IAN TREHEARNE

Application ref 2020/5974/P Demolition of existing dwelling and construction of replacement dwelling with basement and associated landscaping

Application ref 2020/5974/P Demolition of existing dwelling and construction of replacement dwelling with basement and associated landscaping

Figure 4 Existing rear elevations Property boundary marked in yellow.

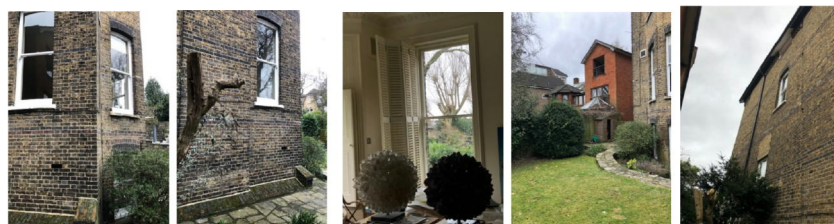
The two gardens are at approximately the same level at this point, as shown by the extract from the existing rear elevation forming part of the application at Figure 4, on which I have added the location of the property boundary in yellow.

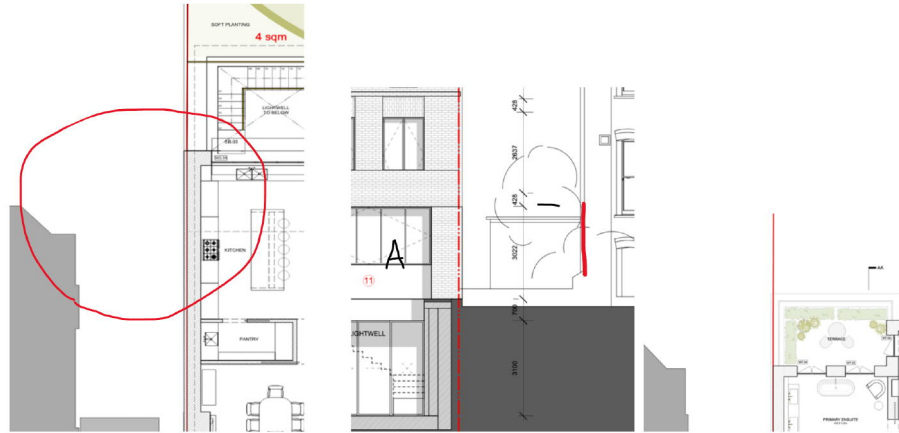
At first floor level the rear wall is cut back to align with the rear wall of no 5 with a proposed terrace at first floor level proposed adjoining the boundary and at a height of some 3.5 metres or 4 metres to the top of the parapet. These proposed features are shown on the three drawing extracts at Figure 6, below, both from the proposed plans forming part of the application.

The left-hand extract shows the relationship of the proposed rear corner of the ground floor at no 5b with the existing layout at no 5. I have drawn a red line round the relevant part.

The central extract shows the rear elevation of the proposed no 5b and the existing no 5. The proposed terrace is marked 'A', and the existing side window I marked with a red line.

The right-hand extract is a plan of the relevant area at first floor level

It will be seen that the overlooking effect of the terrace on both the garden and the window is very marked, and that there will be a clear view from it into my client's living room from a distance of less than 10 metres. There will also be significant overlooking of my client's garden.

The outlook from the side window of my client's flat will be largely obscured at a distance of about 4 metres.

It will be noted also that this relationship, both of the proposed built form and the terrace, is not shown properly on any of these drawings, in that the side window is not marked on plan or elevation, and the proposal for the terrace is masked on the elevation by the brick. In addition, the proposed boundary treatment is not specified on plan or elevation and the very necessary railings which would have to surround the lightwell and staircase in this area are not shown.
